**CONTRACT TECHNICAL DOCUMENTS
VOLUME 2 OF 2
216 PATERSON PLANK ROAD
SUPERFUND SITE
OPERABLE UNIT NO. 2 (OU-2)
CARLSTADT, BERGEN COUNTY, NJ**

Re: **CONTRACT DOCUMENTS – ADDENDUM NO. 1**
216 PATERSON PLANK ROAD SUPERFUND SITE
OPERABLE UNIT NO. 2 (OU-2) FINAL REMEDY
CARLSTADT, BERGEN COUNTY, NEW JERSEY

Re: **CONTRACT DOCUMENTS – ADDENDUM NO. 2**
216 PATERSON PLANK ROAD SUPERFUND SITE
OPERABLE UNIT NO. 2 (OU-2) FINAL REMEDY
CARLSTADT, BERGEN COUNTY, NEW JERSEY

SHEET PILE WALL
ALIGNMENT

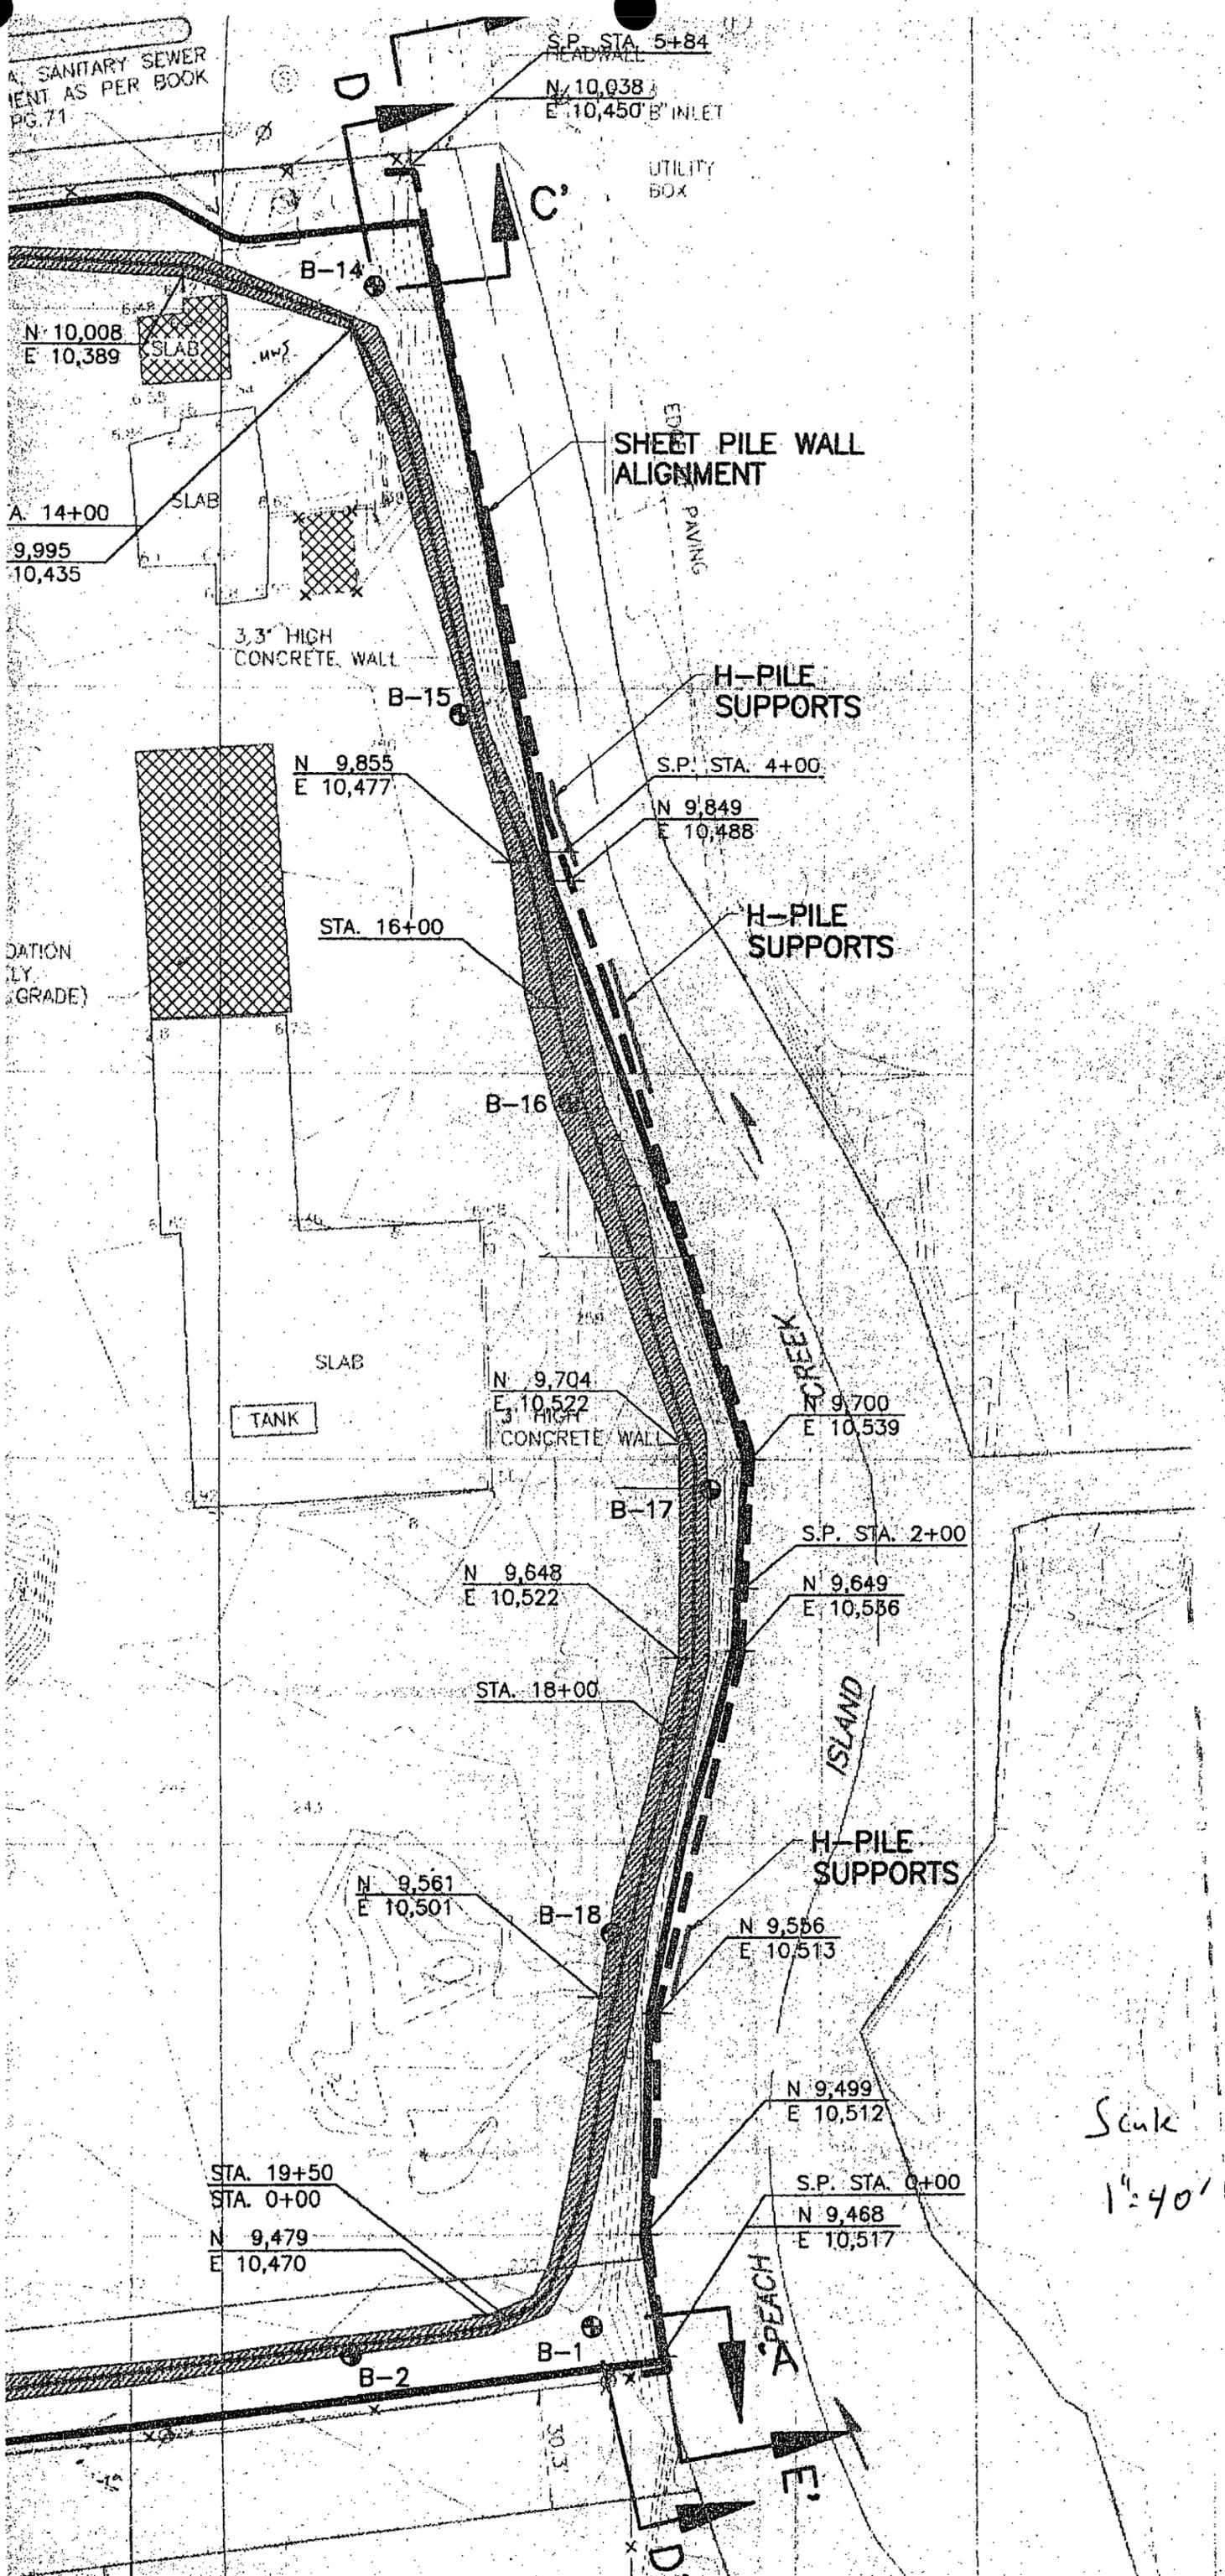
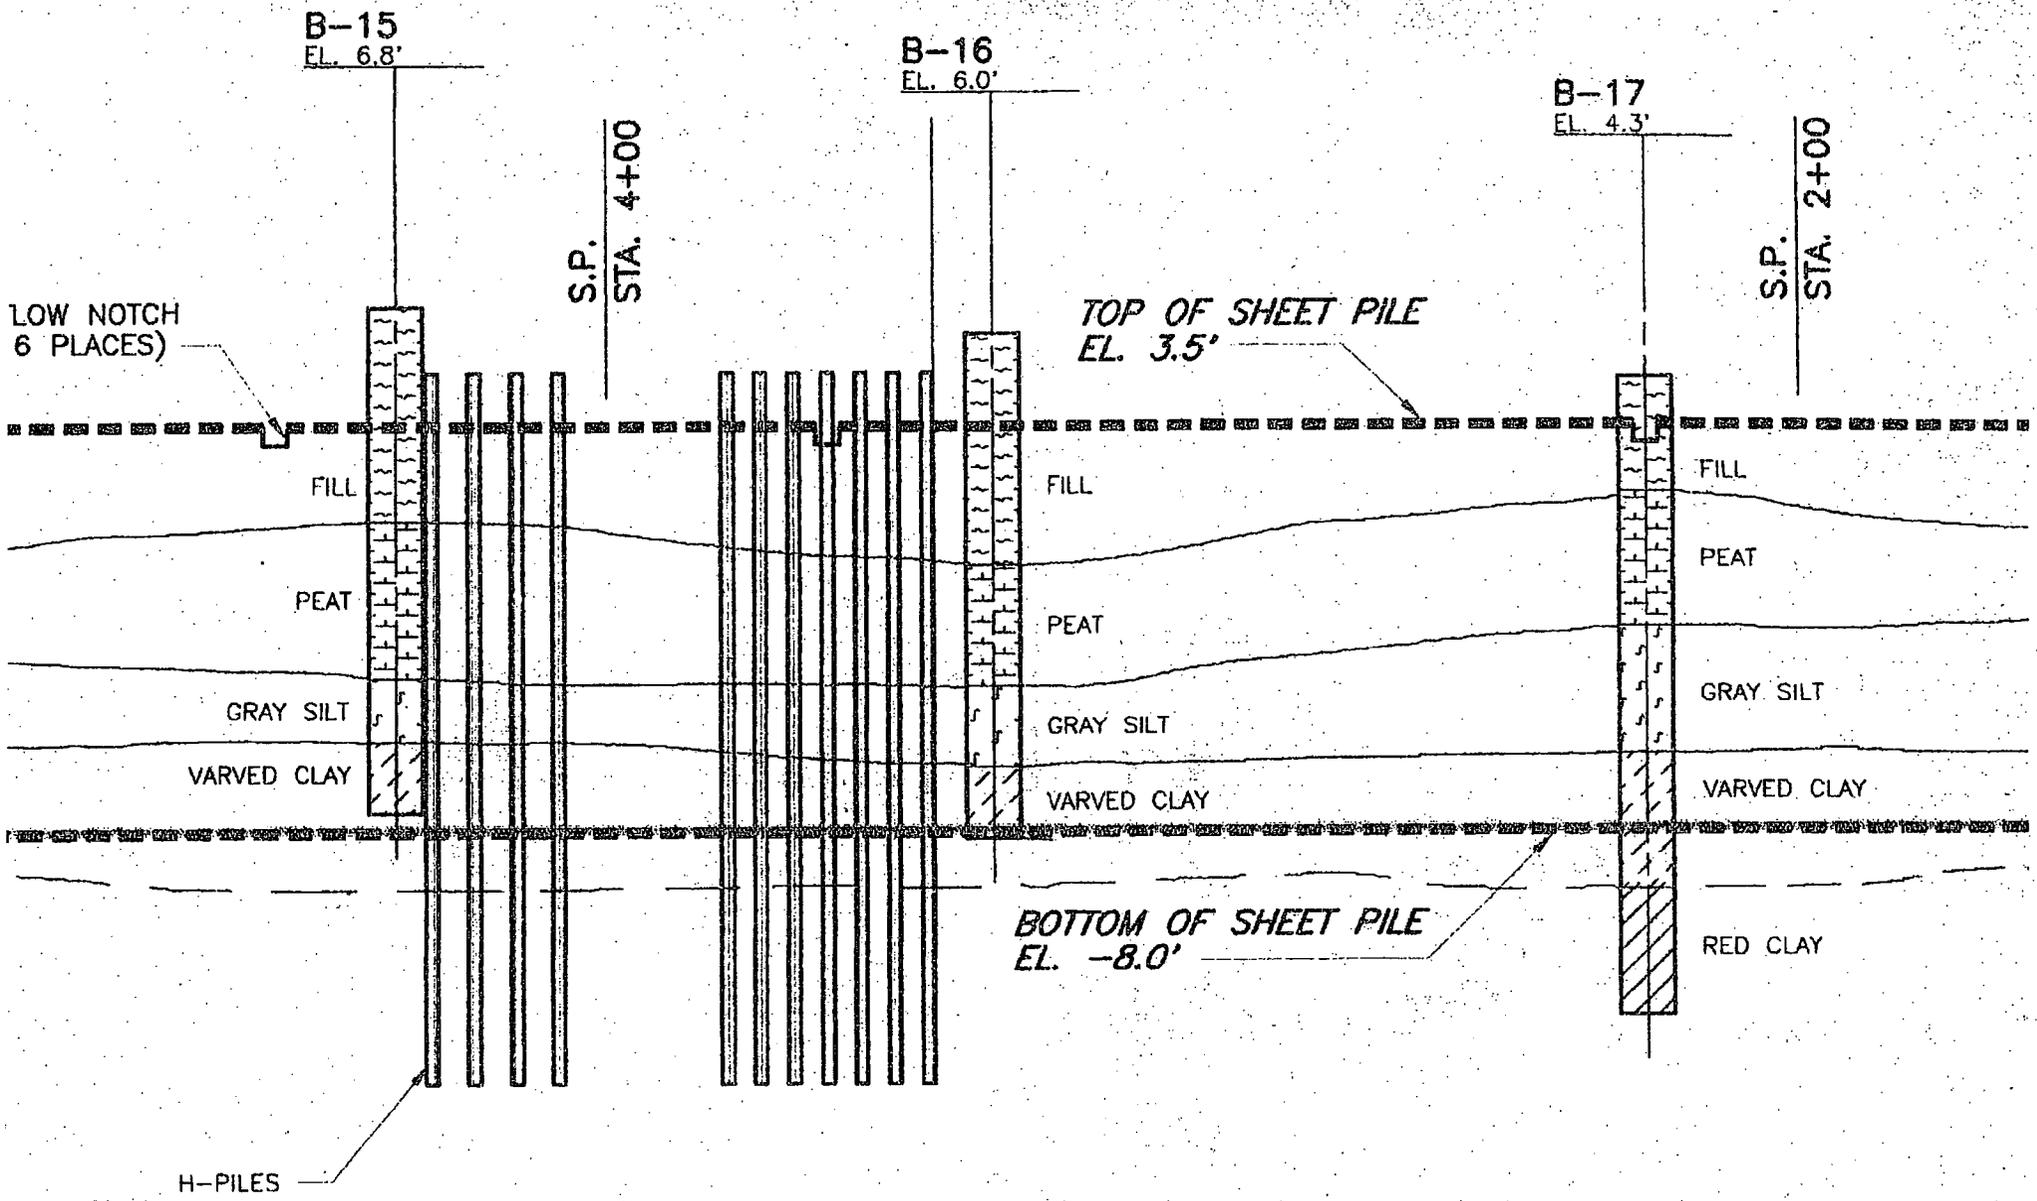
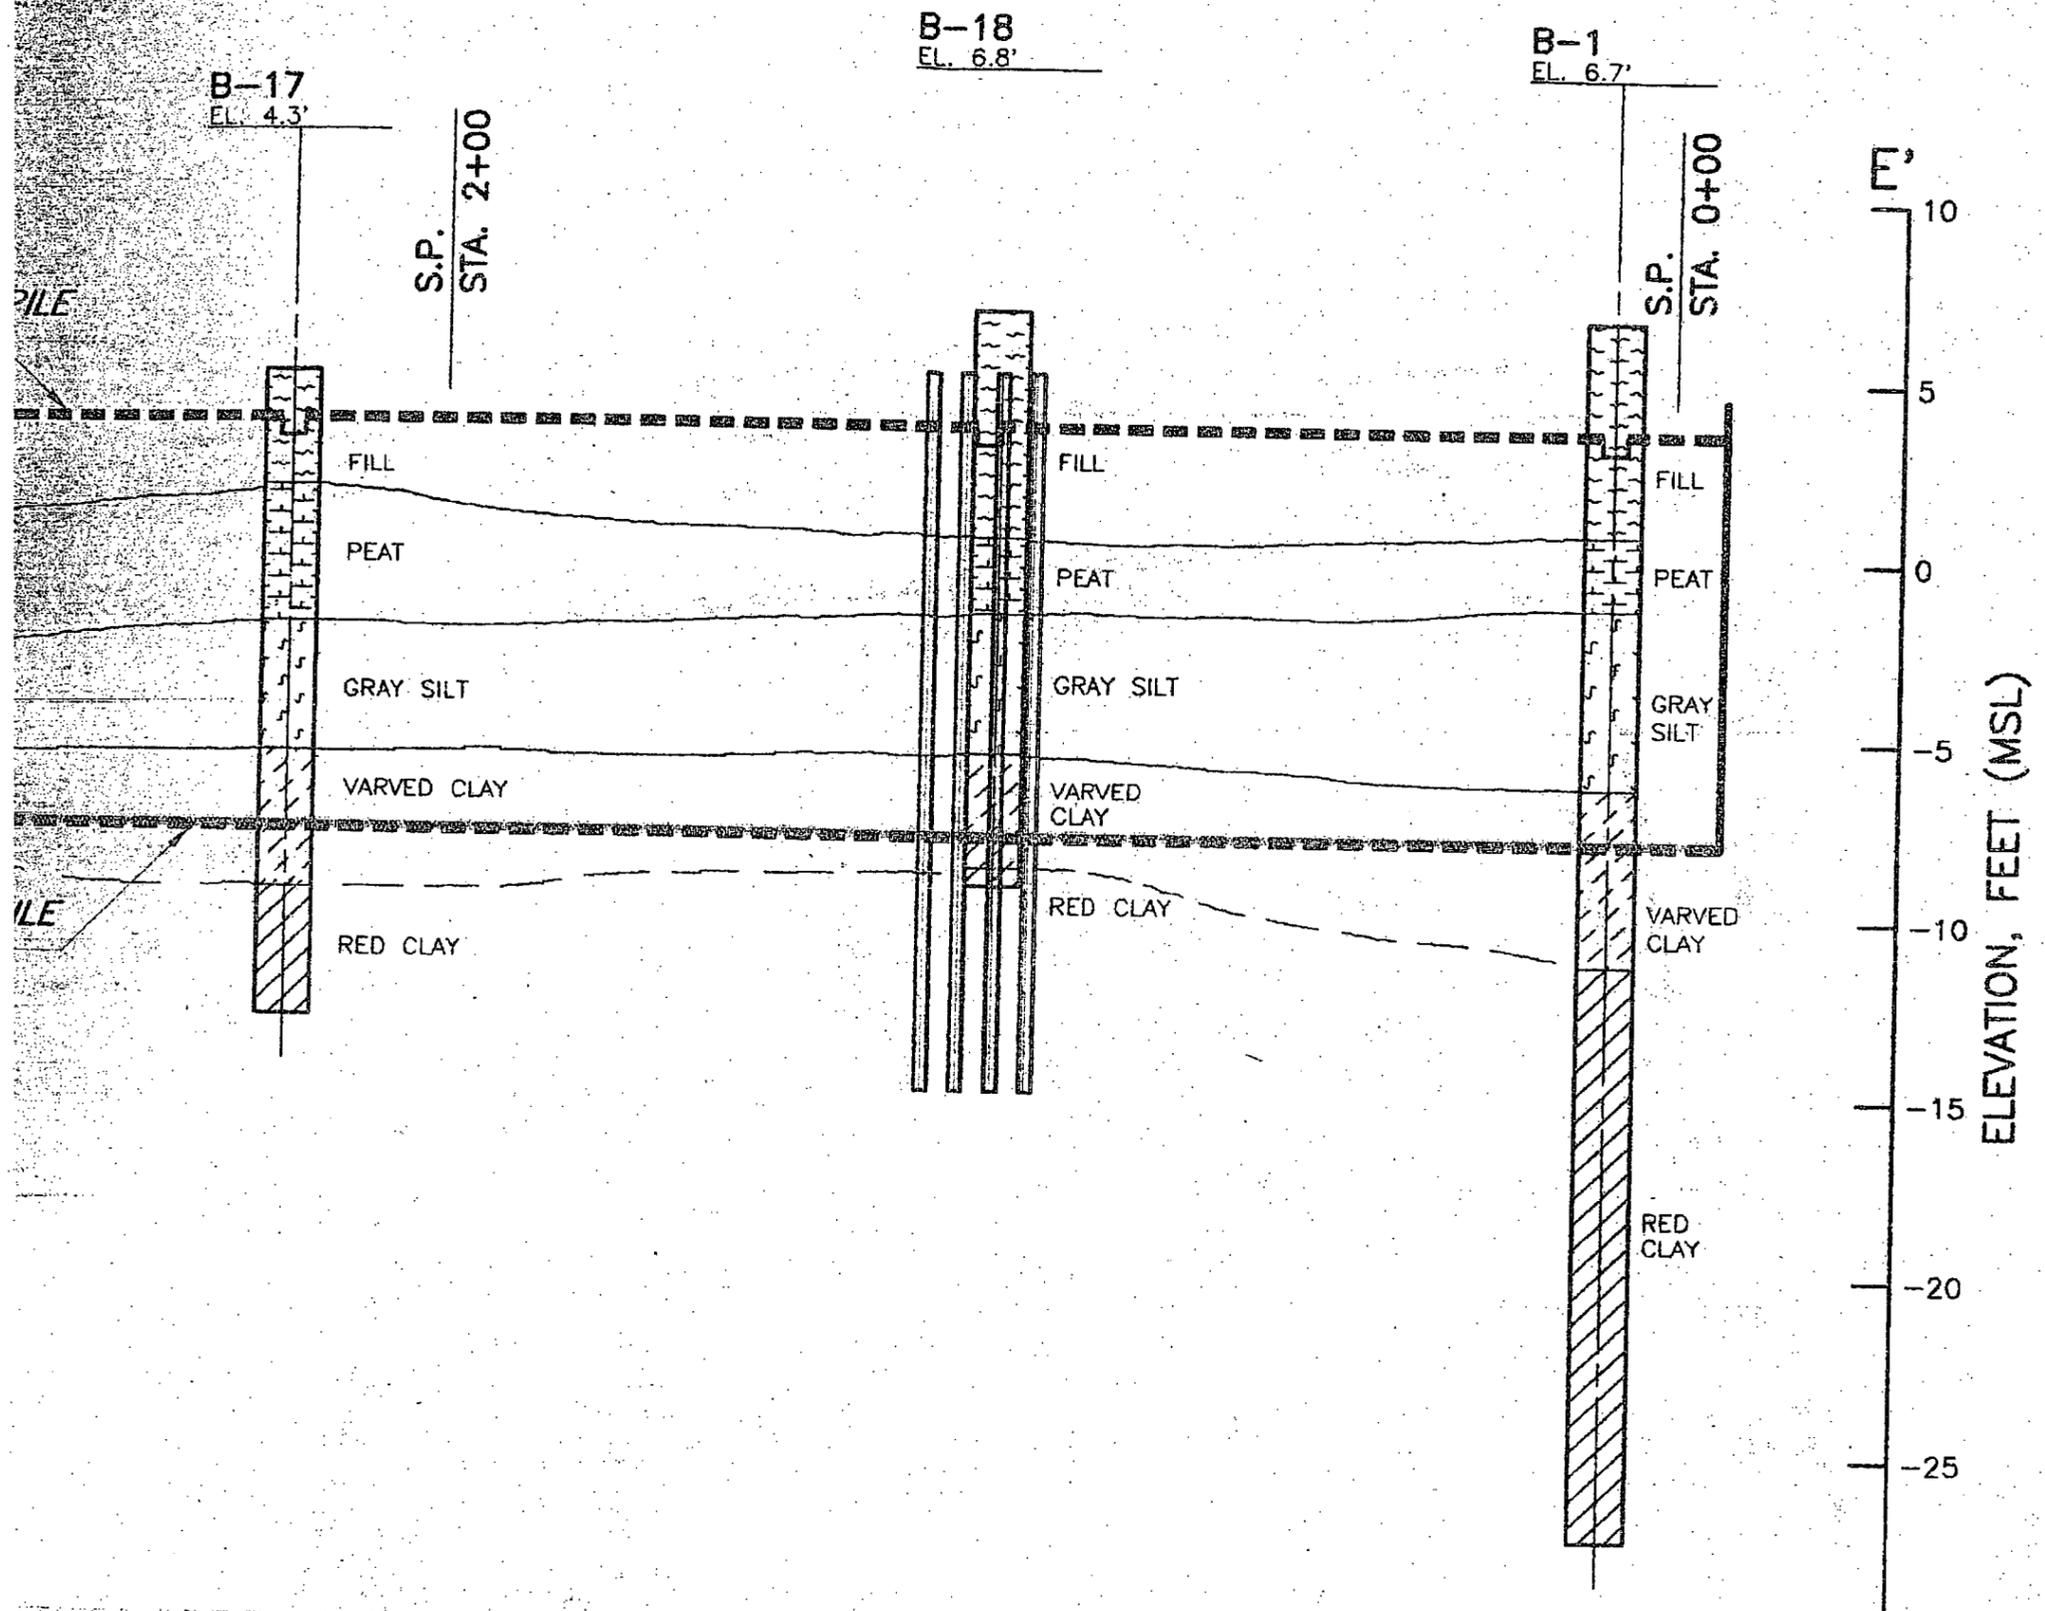
Q15. *“Whereas the existing sheet pile wall has failed rotationally will the existing steel sheet piles interfere with the installation of the new sheet piles?”*

Response #15: During the OU-1 Interim Remedy, sections of the existing sheet pile wall moved (i.e., translated and/or rotated) under the applied construction loads, and a series of H-piles were installed in front of the sheet pile wall to further support and stabilize the wall. See attached for copies of relevant portions of the OU-1 “As Built” Drawings.

Overall, it appears the existing sheet pile wall rotated about ten (10) to thirty (30) degrees from vertical over a significant portion of its length, and the OU-1 “As-Built” Drawings indicate the installed sheet piles had lengths of about twelve (12) feet.

For the OU-2 Final Remedy, the proposed new sheet pile wall will be located about five (5) behind the top of the existing sheet pile wall, and based on the available “as built” design information for the existing sheet pile, the new sheet pile wall should not interfere with the existing sheet pile wall.
